**CITY OF KELOWNA  
MEMORANDUM**

**APPLICATION NO.** Z07-0048  
**AT:** 845 Mayfair Road.

**PURPOSE:** TO REZONE THE SUBJECT PROPERTY FROM RU1 – LARGE LOT HOUSING TO RU6 – TWO DWELLING HOUSING IN ORDER TO CONSTRUCT SEMI-DETACHED HOUSING.

**Date:** July 4, 2007  
**File No.:** Z07-0048  
**To:** Planning & Development Services Department (AW)  
**From:** Development Engineer Manager (SM)  
**Subject:** 845 Mayfair Road – Lot 6, Plan 22026, Sec. 27, Twp. 26, ODYD

LEFT ELEVATION

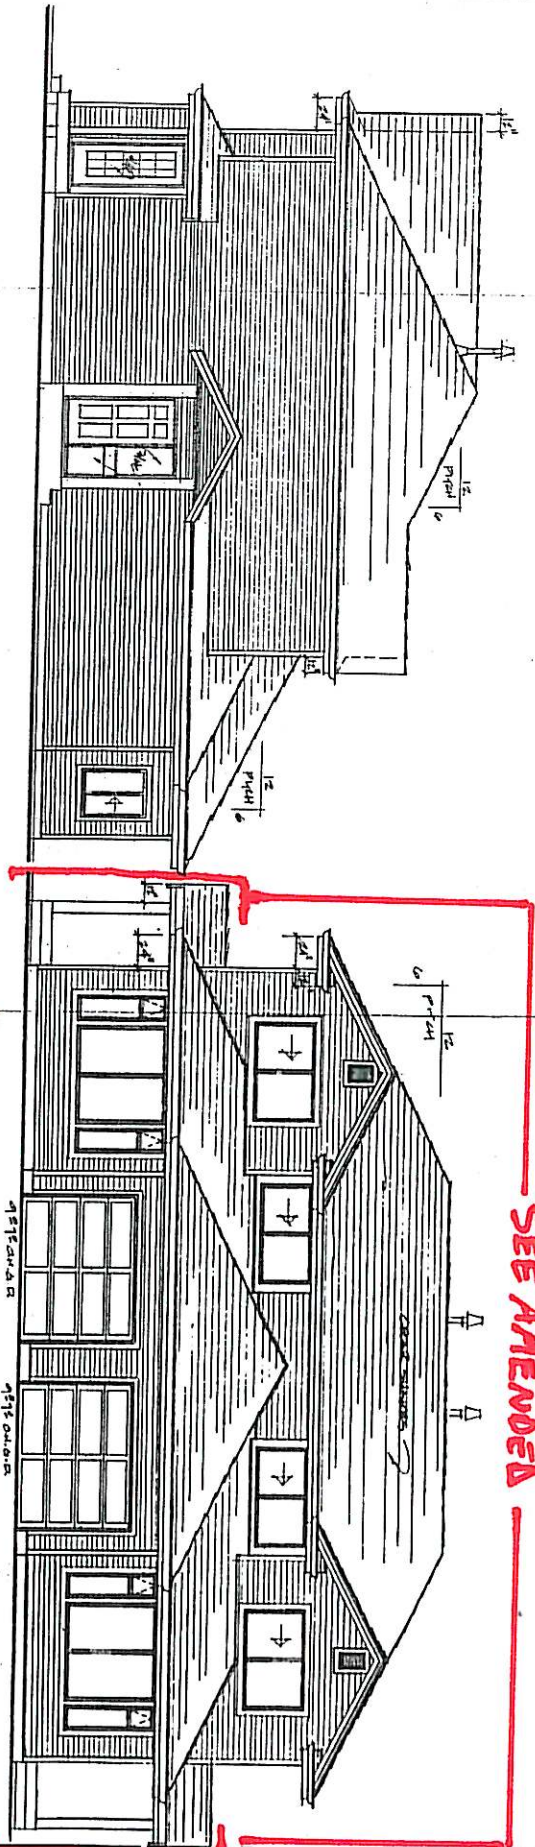
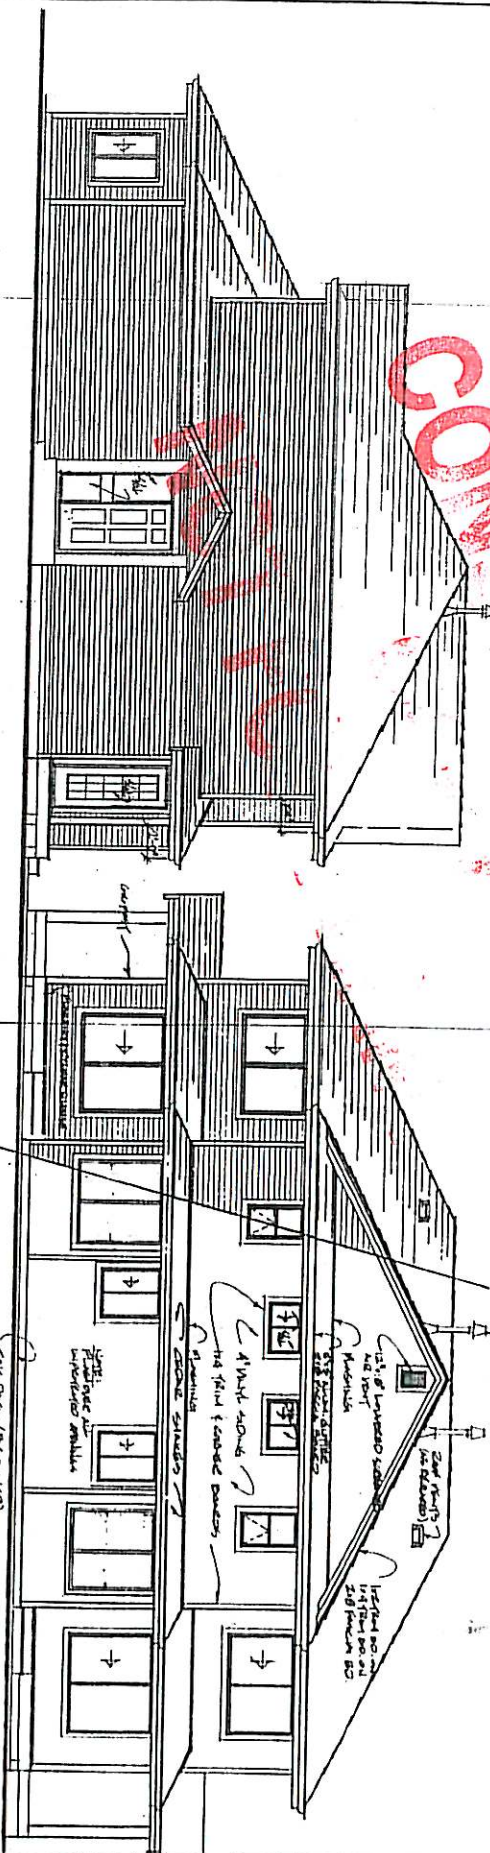
The proposal conforms to the City's Zoning Bylaw No. 8000 and the lot is well suited for the RU6 zone. The applicant was cooperative and worked with Staff to improve the design of the proposed development. The design was modified so that the principle entrances fronted Mayfair Road, and in turn created a more welcoming façade.

**Figure 1 - Present Water Services**

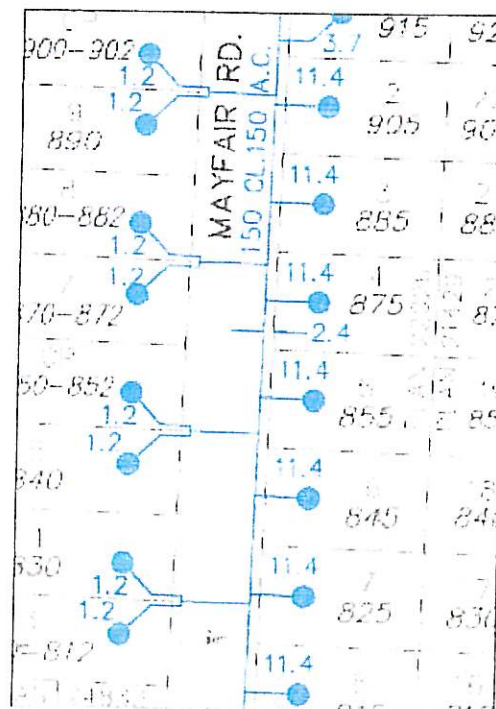
We understand that a rezoning application has been made for the property located at 845 Mayfair Road. The lot has one 19mm un-metered domestic service to the site off the 150mm water main on Mayfair Road as shown in Figure 1.

For a duplex to be constructed, each unit must have a separate water service. In this case, a new service connection is required from the 150mm water main to the curb stop at the property line, and a new private pipe from the curb stop to the premises. The owner is responsible to install the water service line from the property to the building. BMID staff will install the water service from the watermain to the property line. Work is to be completed via a BMID issued work order, and the cost of materials and labour are billable to the property owner. The estimated cost for this work to the owner is **\$1 500.00**.

At the time of building construction, prior to water service hook-up, the applicant must come into the BMID office to apply for a second domestic connection and pay for the connection fee. The connection fee is **\$300.00** for a standard 19mm single family residential unit as prescribed in Bylaw No. 667.

A meter assembly is also required for each unit of the duplex and is to be installed by Corix Utilities. The cost for both meters based on a new installation at a duplex is **2 @ \$312.20**, totalling **\$624.40**.
